WELL API NO. <b>30-015-40047</b>
5. Indicate Type of Lease STATE <input checked="" type="checkbox"/> FEE <input type="checkbox"/>
6. State Oil & Gas Lease No.
7. Lease Name or Unit Agreement Name <b>AID 24 State</b>
8. Well Number <b>017</b>
9. OGRID Number <b>372290</b>
10. Pool name or Wildcat <b>Empire; Glorieta-yaso</b>

**SUNDRY NOTICES AND REPORTS ON WELLS**  
(DO NOT USE THIS FORM FOR PROPOSALS TO DRILL OR TO DEEPEN OR PLUG BACK TO A DIFFERENT RESERVOIR. USE "APPLICATION FOR PERMIT" (FORM C-101) FOR SUCH PROPOSALS.)

AID 24 STATE #017

**AID 24 STATE #017 PROPOSED PROCEDURE**

**Proposed P&A**

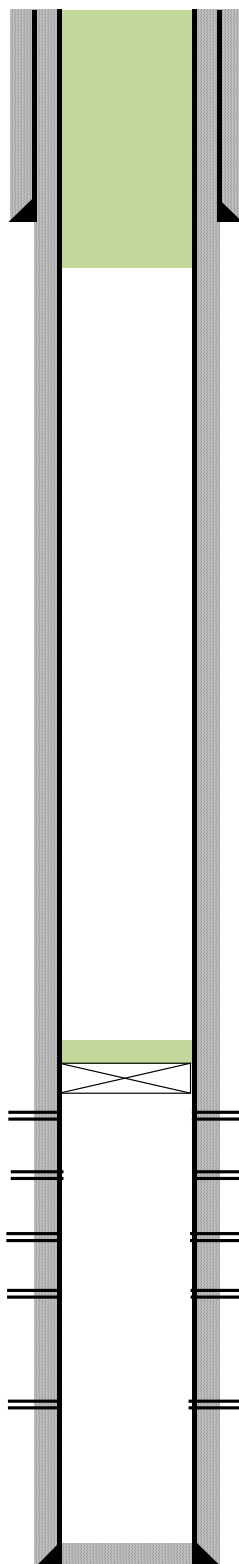
**APPROVED**  
**GC 4/16/26**

1. MIRU pull rods NU BOP pull tubing.
2. **Spot 18 sx cmt 5266' - 5100' - T Tubb - WOC & Tag @ 5100' or higher**
3. RU wireline run GR/JB to 3,740' set CIBP 3,730'.
4. Load and roll hole pressure test casing 500psi for 30 minutes.
5. Run CBL from 3,730' **with zero psi, keep hole loaded & log** to surface.
6. TIH spot 25 sxs of class C cement on top of CIBP from 3,730', WOC tag at 3,480' (Yeso, Glorieta).
7. **Spot 25 sx cmt 2050' - 1850' - T Grayburg**
8. **Spot 25 sx cmt 1650' - 1450' - T Queen**
9. **Spot 37 sx cmt 1075' - 700' - T 7Rivers & Yates**
10. MUH spot at 529'-surface, 53 sxs of class C cement (Shoe). **WOC & Bubble test - verify cmt to surface on both strings casing**
11. Cut off well head, install dry hole marker.  
**Plugs may change based on CBL.**
